RFQ NUMBER
RMA10015

LINE	QUANTITY	UOP	CAT NO.	ITEM NUMBER	UNIT PRICE	AMOUNT
***** ADDENDUM NO. 2 *****						
THIS ADDENDUM IS ISSUED TO PROVIDE THE ATTACHED BID CLARIFICATION, TECHNICAL QUESTIONS & ANSWERS, PICTURES DRAWINGS, CALENDAR, MANDATORY PRE-BID SIGN IN SHEET AND TO EXTEND THE BID OPENING DATE AND TIME.						
BID OPENING CHANGED TO: 04/15/2010 AT 1:30 PM.						
***** END OF ADDENDUM NO. 2 *****						
0001	1	LB		570-65		
REPAIR OF RAILROAD BRIDGES ON THE SBVR AND WVCR						
***** THIS IS THE END OF RFQ RMA10015 ***** TOTAL:

Addendum #2 – RMA10015 – Bridge Repair – SBVR & WVCR

West Virginia Dept. of Transportation State Rail Authority
West Virginia Central Railroad
Bridge Inspection Report
Bridge WVCR 28.8
West Virginia Central Railroad over Tygart Valley River and Barron Ave.

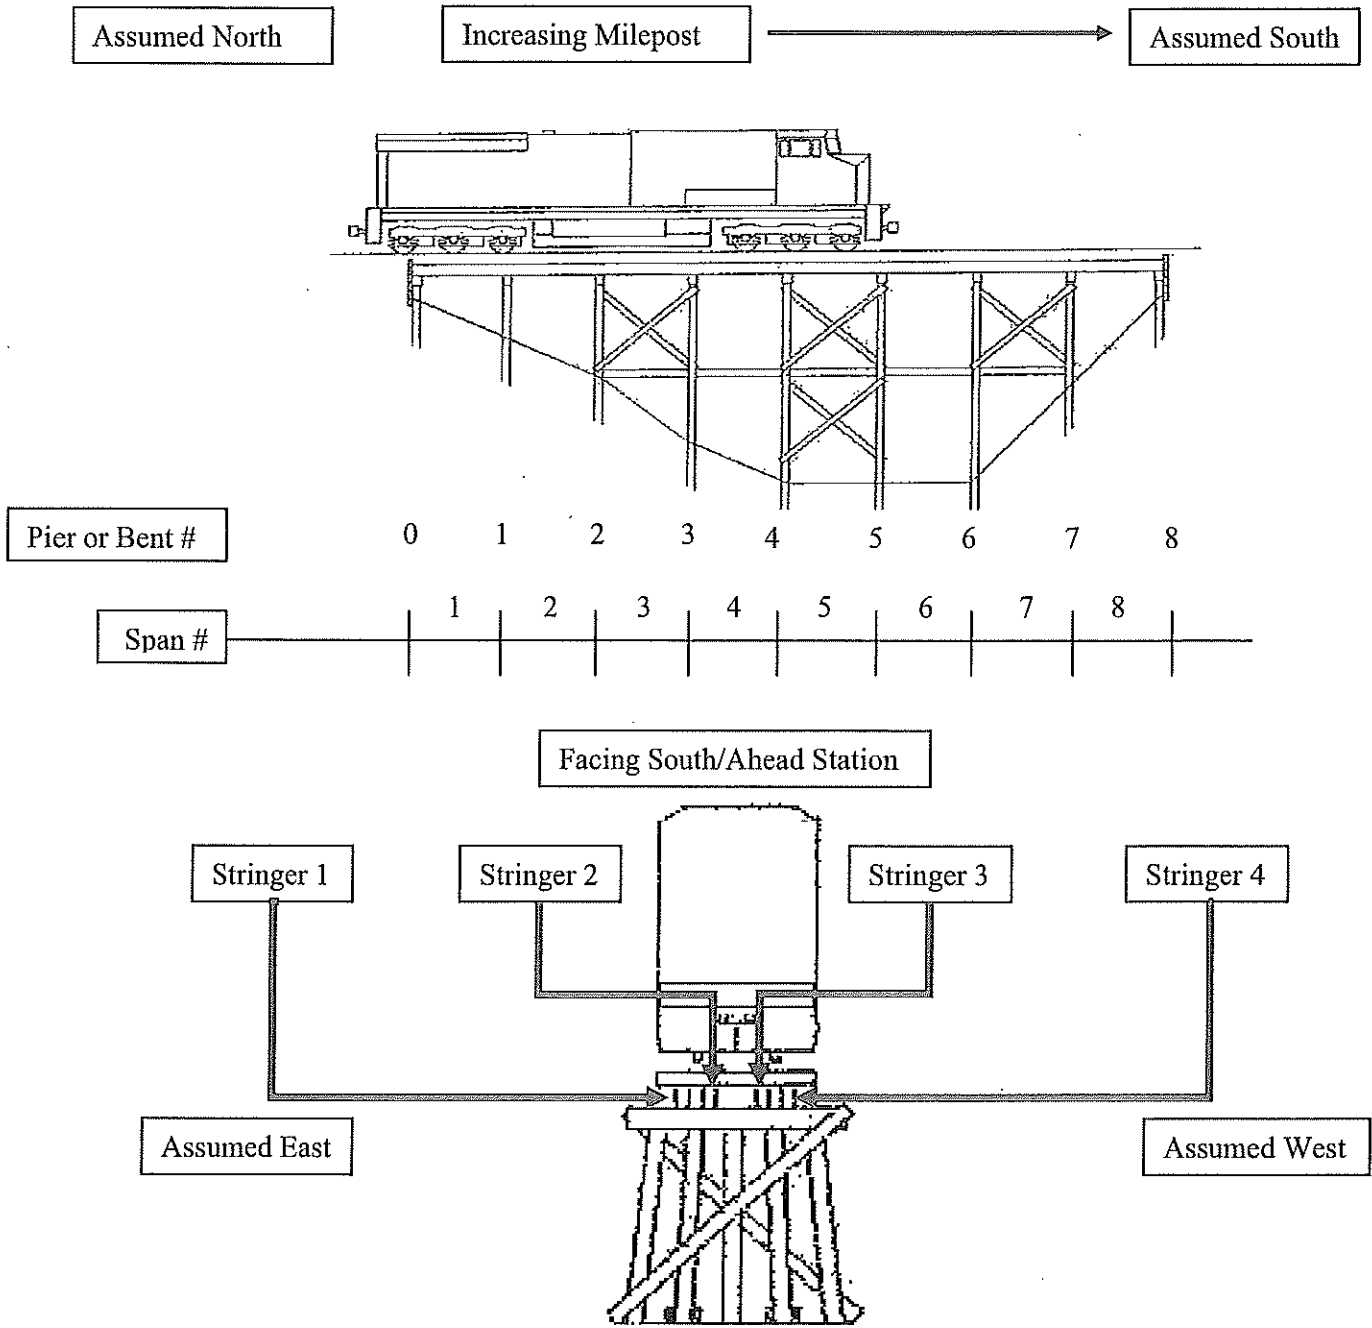
Clean and paint the top lateral bracing gusset plates on Span 2. This has been completely removed from this project.

See attached picture showing the two cross frame brace members. (attachment)
